October 14, 2025

**RE: Public Comments on Proposed Air Permit No. 4911-015-0011V-05-1 for
Expansion of the Bowen Steam-Electric Generating Plant**

Figure 1: Atlanta Area Ozone Design Values, 2018 to 2024 ²⁴

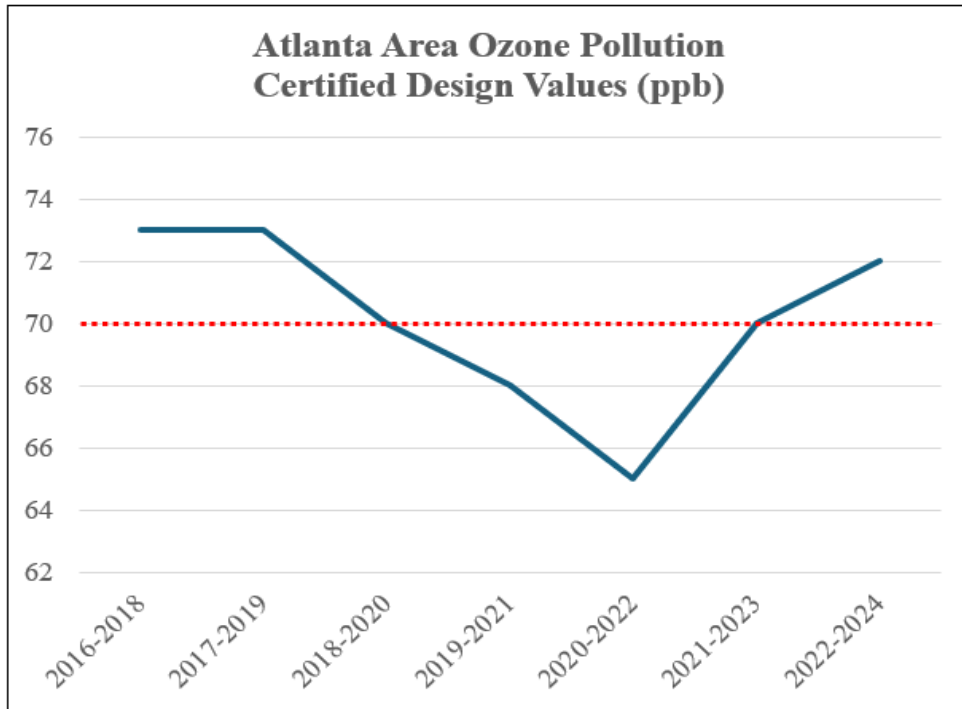
Atlanta is designated as a maintenance area for the primary 8-hour National Ambient Air Quality Standard (“NAAQS”) for ozone, but certified 2024 monitoring data reveals that the Atlanta area is once again exceeding this federal health-based standard. Similarly, the latest certified monitoring data shows the Atlanta area is exceeding the primary annual NAAQS for PM_{2.5}. Issuing this permit without stronger control requirements and enforceable emission offsets would risk worsening these existing NAAQS exceedances, contrary to the Clean Air Act’s preventive intent.

Figure 2: NOx emission rates from Georgia Power’s Plant McDonough Unit 4a from 2017-2024⁴⁹

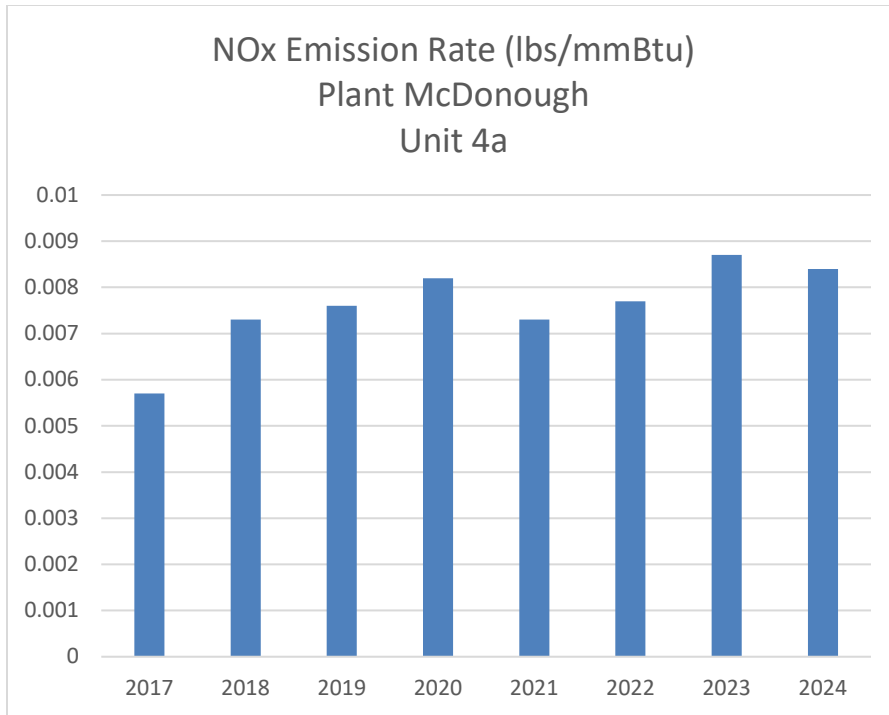
- ***NOx Emission Reduction Opportunities at Existing Plant McDonough Units:*** Like the existing Plant Bowen units, the NOx controls at Plant McDonough can be optimized to achieve lower emission rates. The graph below shows annual NOx control rates for Unit 4a since the unit began operation in 2017. In 2017, the annual emission rate for NOx was less than 0.006 lbs/MMbtu, but the controls were operated at much lower control efficiencies in subsequent years, resulting in the NOx emission rate rising to nearly 0.009 lbs/MMbtu in subsequent years (see the graph below). The same pattern is seen in the data for the other five combined cycle units at this facility. Therefore, it appears that optimized NOx emission controls could be operated at this facility to reduce emissions by approximately 30% below what is currently being emitted.

Figure 3: Operation of Plant Bowen coal-fired unit from 2005 to 2024⁵¹

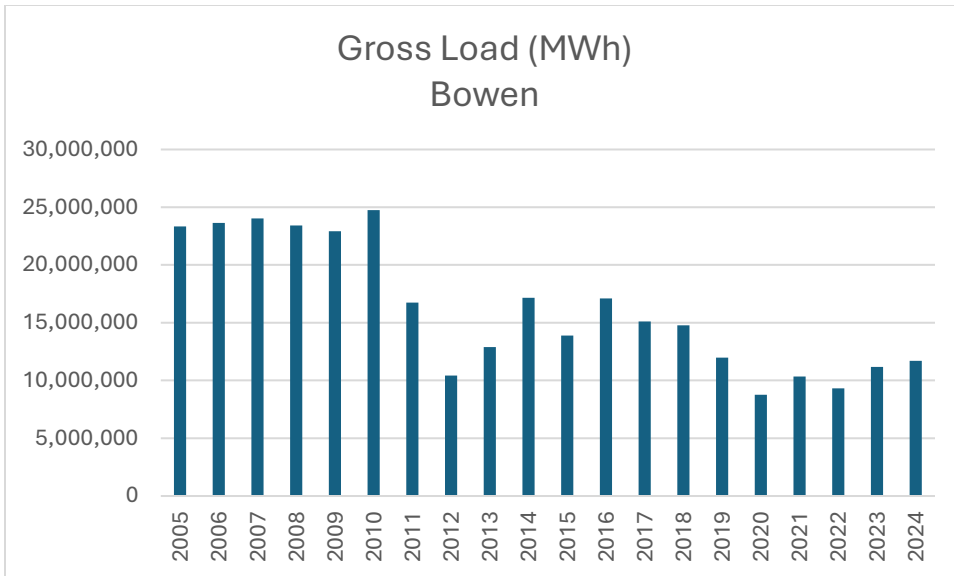
Regarding Plant Bowen’s coal-fired units, another—and better—option would be for Georgia Power simply to retire them. These highly polluting units were built in the 1970s and have been in operation for more than fifty years. At a minimum, EPD and Georgia Power should place strict limits on the hours of operation of these units. As indicated in the graphs below, in the last four years, the coal-fired units at Plant Bowen have operated at less than half of historical generation rates, and NOx emissions in recent years have ranged between 4,800 and 6,300 tons per year. If these units were to return to historical operation levels, NOx emissions would be expected to rise as high as 14,000 tons per year, assuming similar operation of existing NOx controls. Given current trends in ozone levels in the Atlanta area, such a significant increase would almost certainly interfere with EPD’s ability to attain and maintain compliance with the NAAQS.⁵⁰

Figure 5: Location of NO₂ Monitors Relative to Project Site

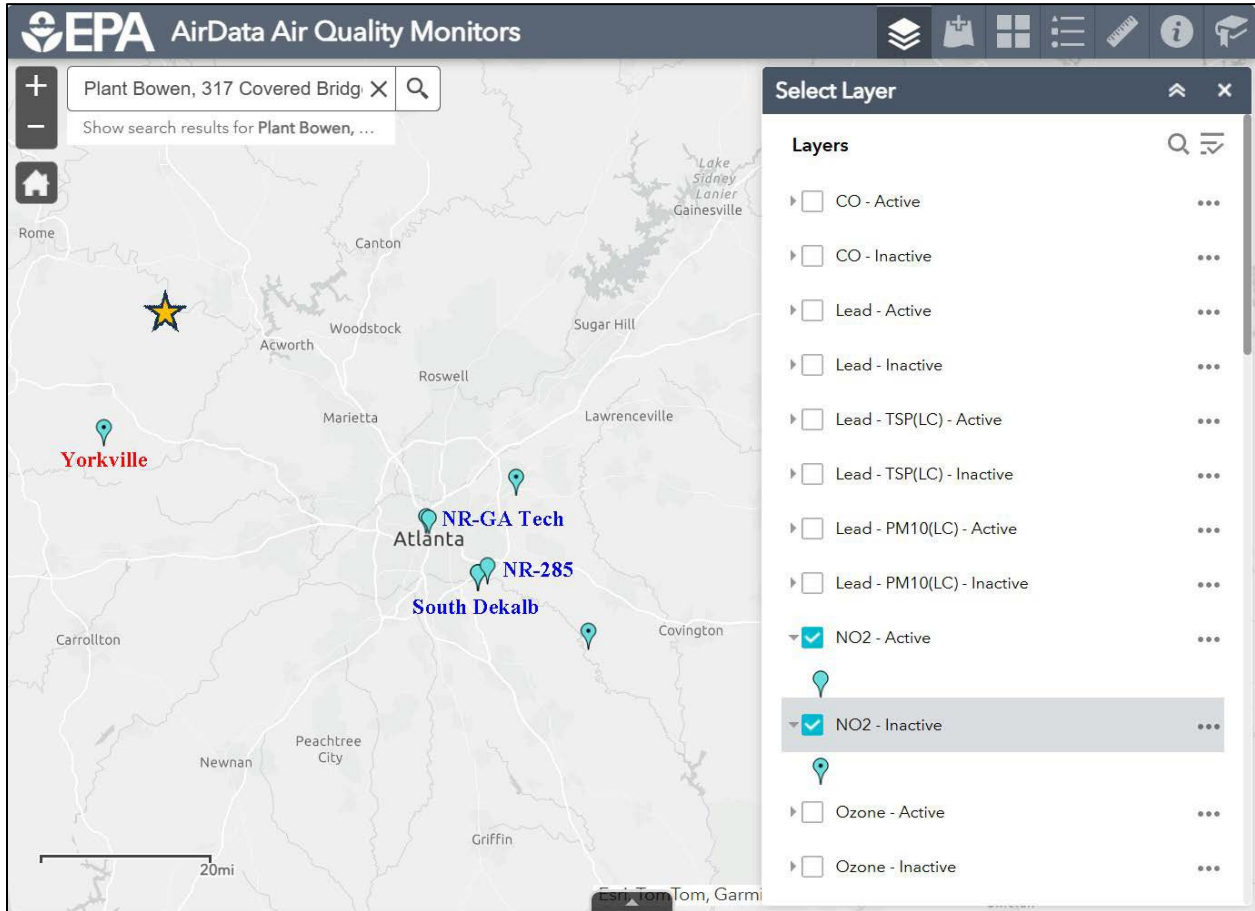
In addition, unlike the inactive Yorkville monitor, all three active NO₂ monitors and all five active or recently active PM_{2.5} monitors in the Atlanta area are located to the southeast of the plant—the primary plume direction.⁷⁴ As a result, these monitors not only provide much more recent data but are more representative of background air quality in the areas that are most likely to be affected by the increased emissions from the proposed project.
